STAFF RECOMMENDATION
4207 Aberdeen Rd
September 20, 2017

Application: New construction – addition with setback determination
District: Cherokee Park Neighborhood Conservation Zoning Overlay
Council District: 24
Map and Parcel Number: 103120038
Applicant: Van Pond, architect
Project Lead: Jenny Warren, jenny.warren@nashville.gov

Extensions + Renovations to:
The Andrews Residence

Proposed Site Plan

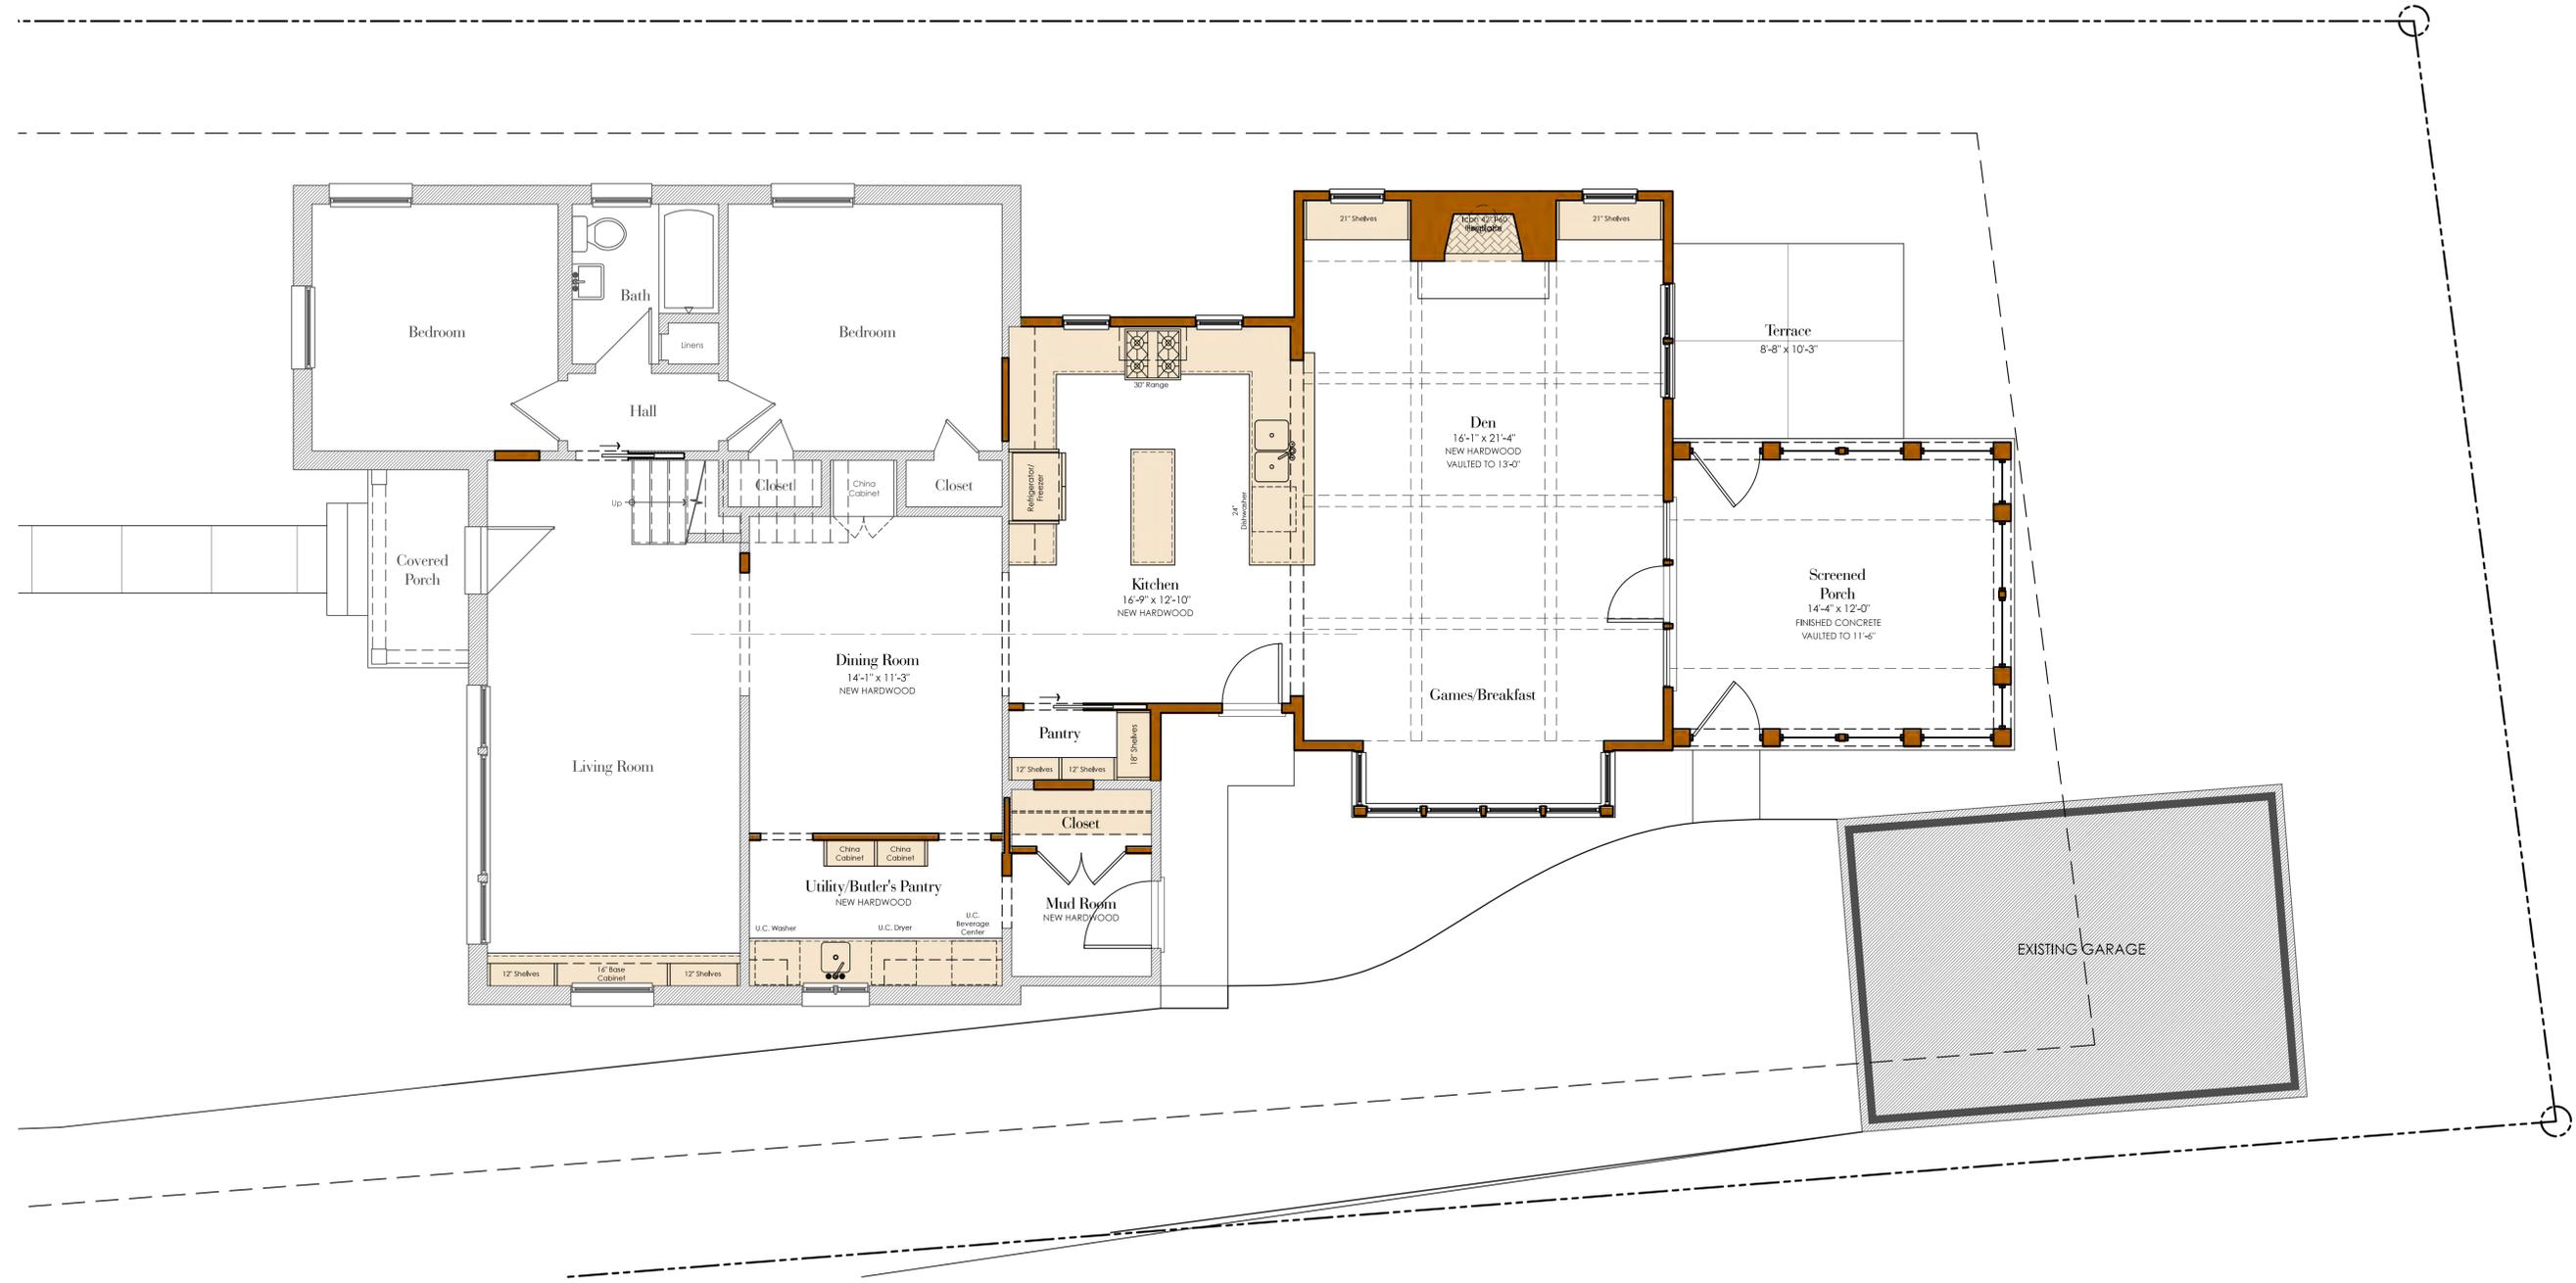
Given these site constraints, Staff finds that a closer separation is acceptable in this situation. However, the proposed 2’8” (two foot, eight inch) separation from the corner of the screened porch is too close. Staff recommends that the screened porch on the rear of the addition be moved to the north side of the house, trading places with the terrace. Staff would support allowing the screened porch to extend up to two feet into the rear setback in order to accommodate a greater separation from the garage. With this change, the closest point between the garage and the addition would become the 8’ (eight foot) distance between the den and the garage.

With the condition that the screened porch is moved such that at least an 8’ (eight foot) separation between the addition and the garage can be established, Staff finds that the project meets section II.B.1.c and II.B.1.h.2.

1. The design shall be altered such that the addition sits at least 8' (eight feet) from the existing garage.
2. Staff shall approve the final details, dimensions and materials of windows and doors and the roofing color, prior to purchase and installation; and,
3. The HVAC shall be located behind the house or on either side, beyond the mid-point of the house; and

1 Proposed Rear Elevation

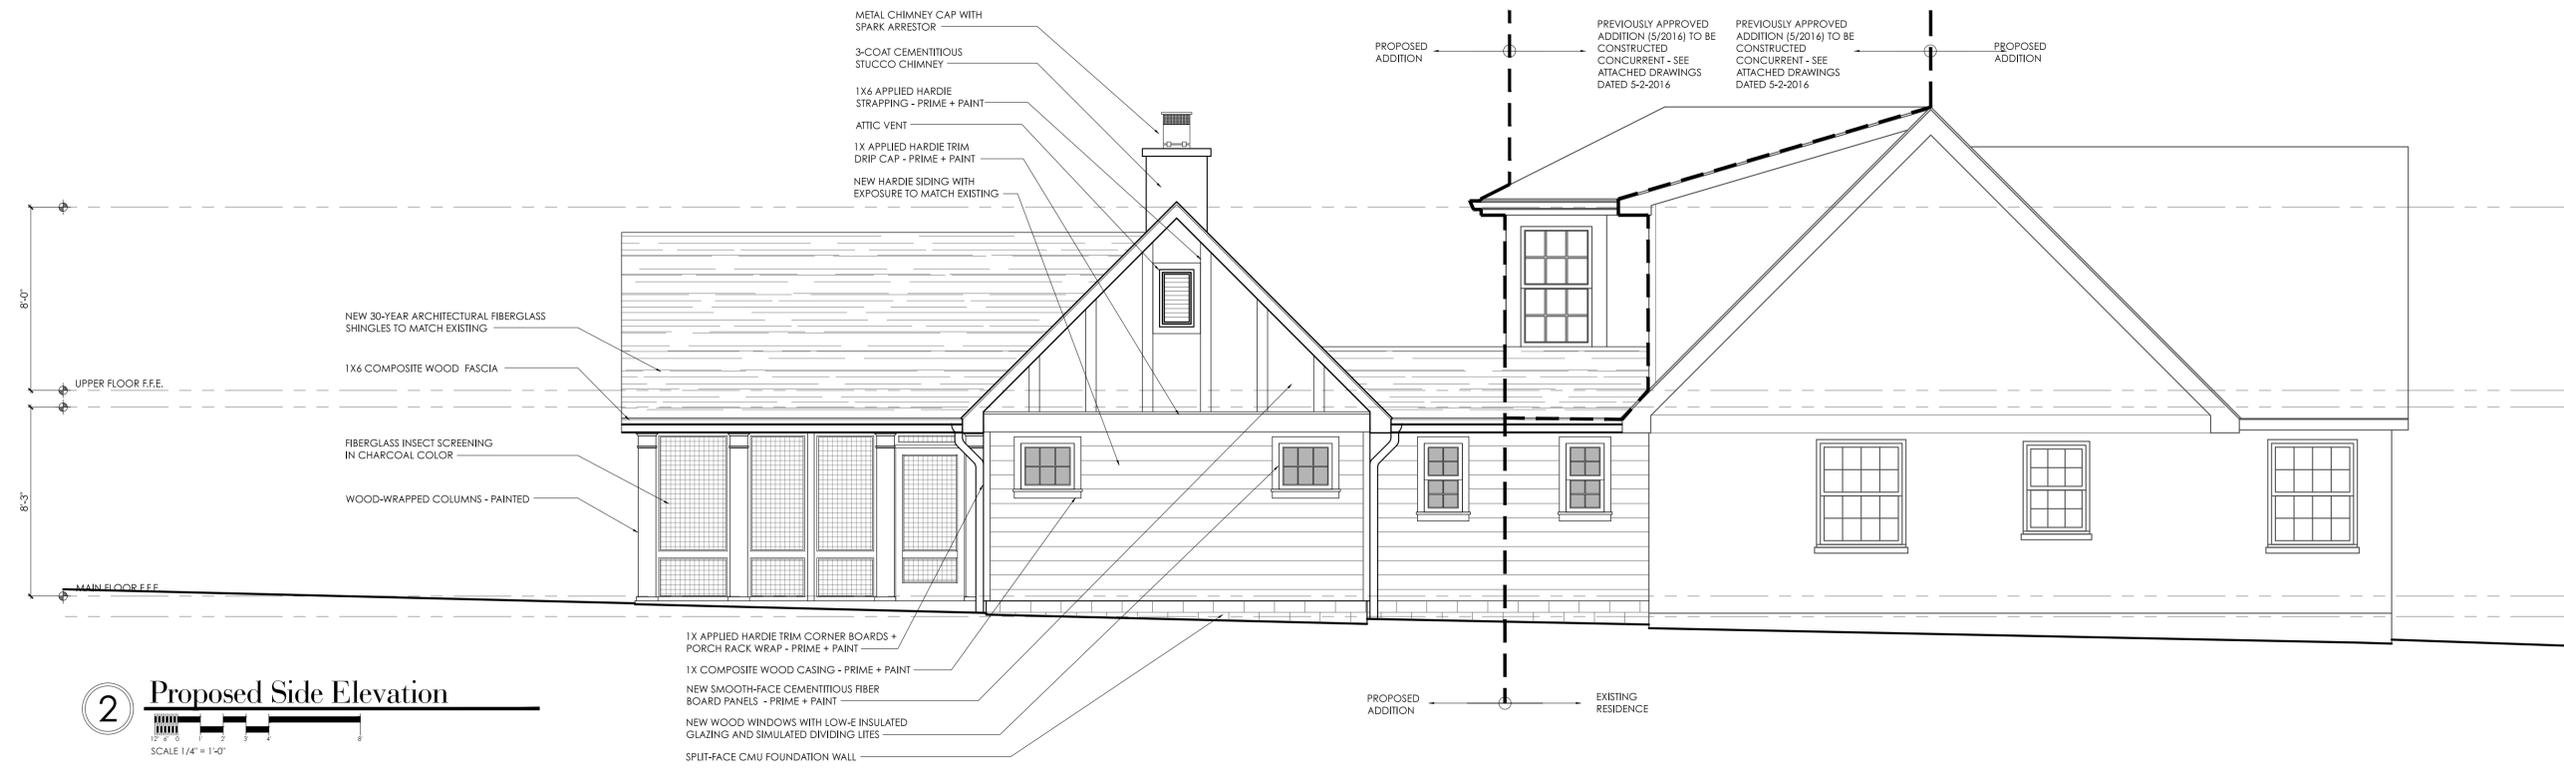
The rear addition will be located behind the original house. The ridge height of the original side-gabled house is approximately 22'6" (twenty-two feet, six inches) high. The addition connects to the rear of the existing house with a one-story front facing gable that will be approximately 12' (twelve feet) high. Beyond this portion is a side-gabled

den with a ridge height of approximately 18' (eighteen feet). The chimney and cap will rise an additional few feet. The screened porch will have a rear-facing gable with a 16' (sixteen foot) ridge height. As all portions of the addition will be lower than the existing

The addition is narrower than the original house, with a maximum width of 27' (twenty-seven feet), compared to the 35'6" (thirty-five foot, six inch) width of the existing house. Where the addition connects to the rear of the house, the side walls are inset 6' (six feet) on the left side and 12' (twelve feet) on the right. The massing is shifted to the left of the site, due to an existing garage along the property line on the right. However, even at its widest point, the new construction will sit slightly recessed from the original side walls of the house.

The primary roof form on the existing house is side-gabled with a 12/12 slope. There is a shed roofed dormer stretching across the rear of the existing house and a second small two story addition with a shed roof off the rear (see Figure 2). As discussed above, the small two story addition will be converted to a hipped roof to accommodate master bedroom renovations. This work was approved last year and Staff finds it appropriate. The newly proposed addition includes front and side gabled roofs. The front gabled portion, which houses the kitchen and connects to the rear of the original house has a 3/12 slope while the other two have a 12/12 slope. The shallow 3/12 pitch is only used on the el connecting the two side-gabled forms, which Staff finds acceptable. The 12/12 slope matches the historic roof pitch.
